UNITED STATES PATENT AND TRADEMARK OFFICE

APPLICATION NO.	FILING DATE	FIRST NAMED INVENTOR	ATTORNEY DOCKET NO.	CONFIRMATION NO.
10/620,376	07/17/2003	Tomokazu Hayashi	10517/173	9710
23838	7590	10/24/2008	EXAMINER	
KENYON & KENYON LLP			HODGE, ROBERT W	
1500 K STREET N.W.				
SUITE 700			ART UNIT	PAPER NUMBER
WASHINGTON, DC 20005			1795	
			MAIL DATE	DELIVERY MODE
			10/24/2008	PAPER

Office Action Summary	Application No.	Applicant(s)	
	10/620,376	HAYASHI ET AL.	
	Examiner	Art Unit	
	ROBERT HODGE	1795

DETAILED ACTION

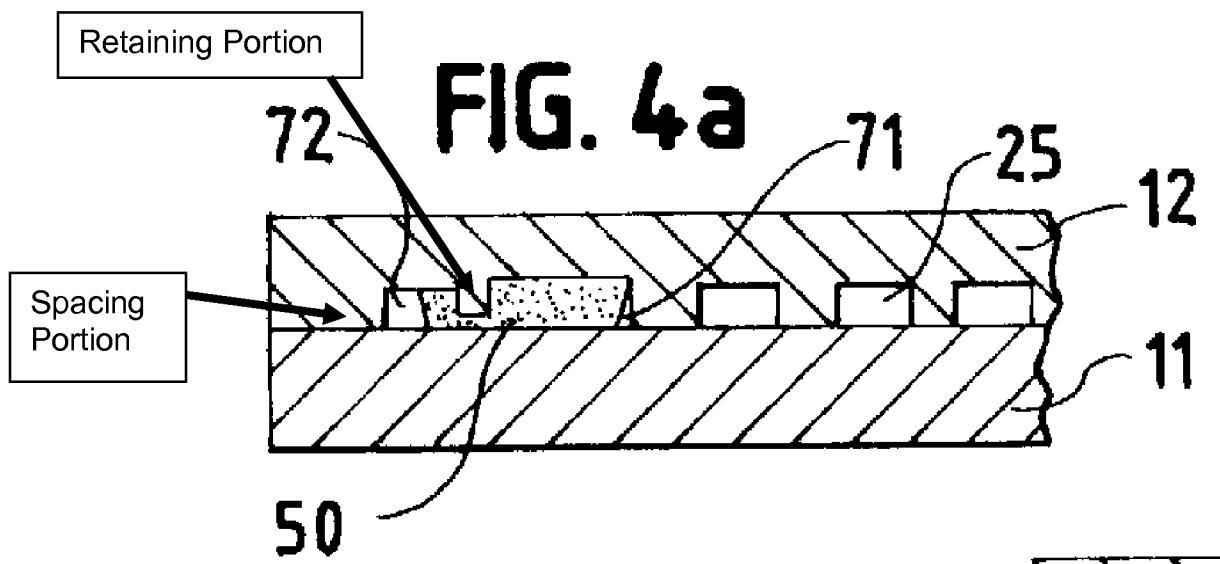
With regards to claim 3, it is unclear how “the surfaces facing each other” can exist when there is only one surface being recited in the claim. As long as the prior art teaches either the retaining portion formed on one surface of a component it will read on claim 3 as recited.

Schmid teaches solid polymer electrolyte fuel cell stacks (which as defined by applicants in the instant specification paragraph [0048] is a low temperature type fuel cell) comprising a plurality of components including but not limited to separators and electrolyte membranes with an adhesive material (inherently pressure sensitive) that is elastomeric and is selected for its specific compatibility of physical and chemical characteristics to be used in solid polymer electrolyte fuel cell stacks, said adhesive material being adhesive and interposed between the plurality of fuel cell components wherein a retaining portion and a spacing portion are formed on a surface of a separator plate (illustrated in figure 4a below);
